From: Ken Gibb, Community Development Director 
To: Mayor and City Council
Date: June 13, 2008
Re: Responses to Questions from City Councillors regarding Seavey Meadows (PLD08-00001; SUB08-00001)

**Testimony Received Regarding the
Appeal of Seavey Meadows
(PLD08-00001, SUB08-00001)
after the June 2, 2008, City Council
Public Hearing, but prior to
close of the record
at 5 p.m., on June 9, 2008**

**Subject: Final Written Testimony from the Applicant
(Seavey Meadows, PLD08-00001, SUB08-00001)**

**Staff Responses to Questions from City Councilors at the June 2,
2008, Public Hearing regarding an Appeal of Seavey Meadows
(PLD08-00001, SUB08-00001)**

Shows row of cottonwoods in question

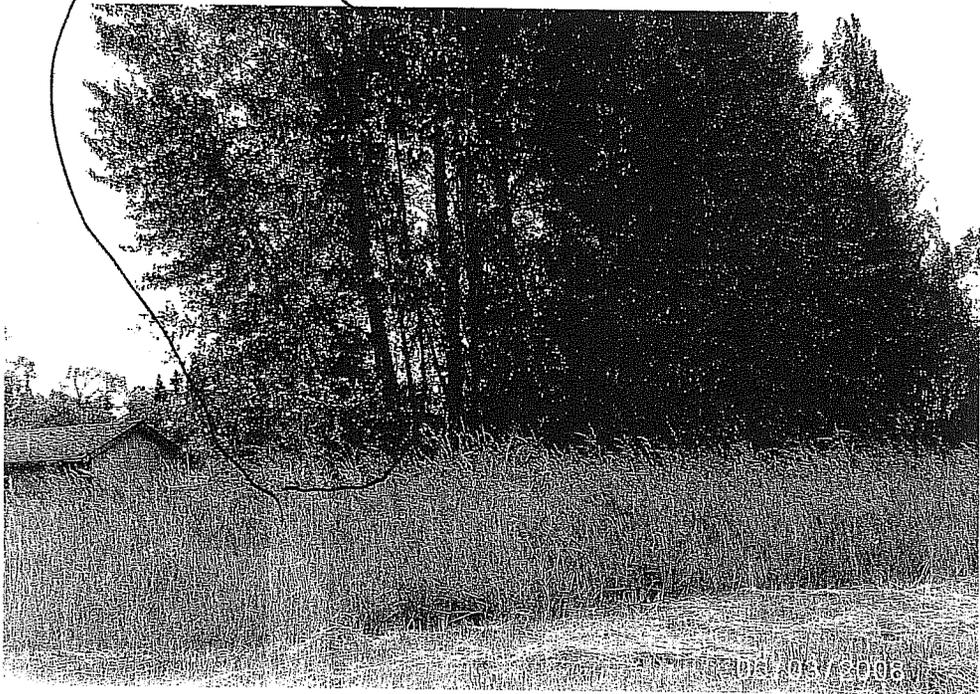
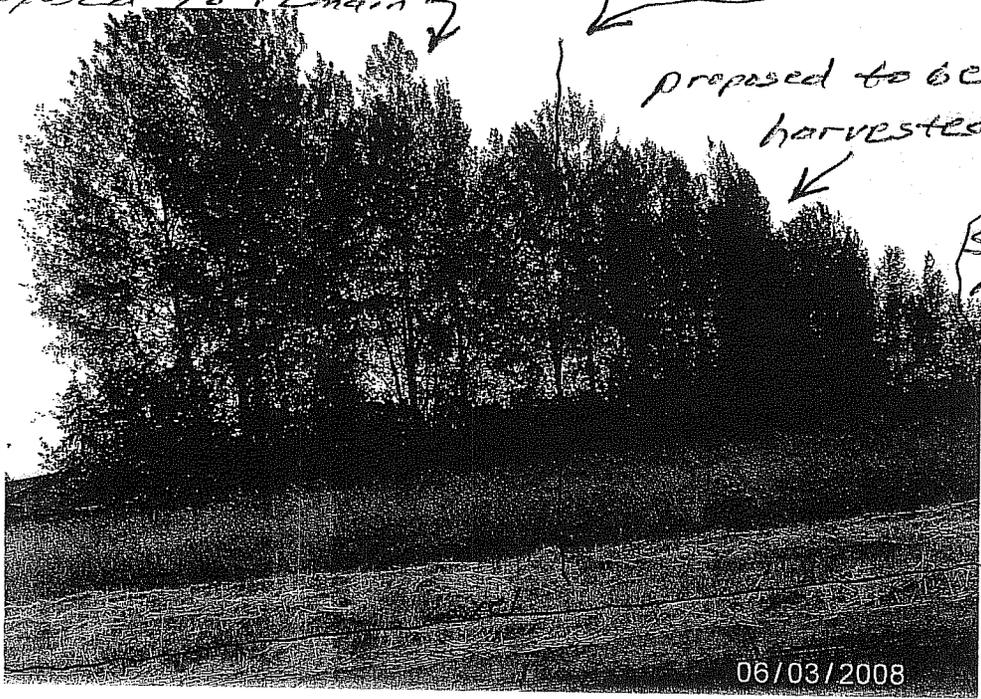
We see these trees as dangerous and a nuisance. The attached photos show how two of these trees are hanging over our shop and shed. Two years ago these trees were barely leaning. Now, the largest one leans 12 feet. Also, there roots sprout cottonwood trees all over our landscaping. And, there sticky seeds and cotton blows all over our yard. It is a mess.

Please remove these trees before we, our guests, and/or our property are hurt.

You can see that several trees lean over our property. I would expect to fall or break off in the next few years.

Right about here is the line delineating what will be cut & what will remain. These remaining will be exposed to wind much more than they are now.
